Attorney Docket No.: 50129/00202

**REMARKS****RECEIVED  
CENTRAL FAX CENTER  
DEC 29 2006****I. INTRODUCTION**

Appln. No. 10/826,199  
Amdt. Dated: December 29, 2006  
Reply to Office Action of September 12, 2006  
Annotated Sheet Showing Changes

FIG. 3c

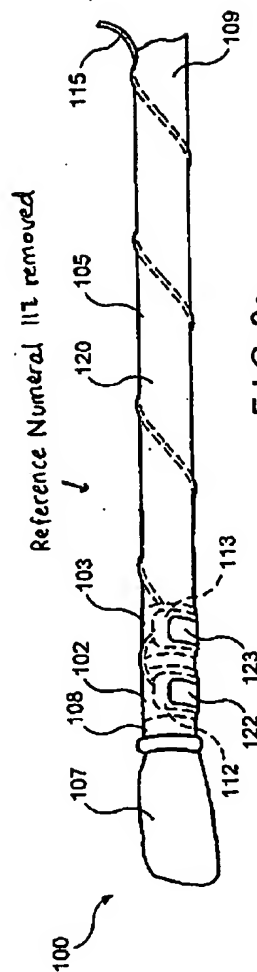
The attached sheet of drawings includes changes to Fig. 3c. This sheet replaces the original sheet including Figs. 3a-c. In Fig. 3c, the reference numeral 117 has been removed. An annotated sheet has been attached to show the changes made to Fig. 3c including an annotation stating the removal of the reference numeral 117.

The Examiner objected to the drawings because the drawings included a reference numeral that was not mentioned in the description. Specifically, Fig. 3a includes a reference numeral 117 that was not described in the specification of the present application. Fig. 3a has been amended to remove the reference numeral 117. A replacement sheet has been provided to replace Figs. 3a-3c. An annotated sheet has also been provided to show the changes made to Fig. 3c including an annotation stating the deletion of reference numeral 117. Thus, it is respectfully requested that the Examiner should withdraw the objection to the drawings.
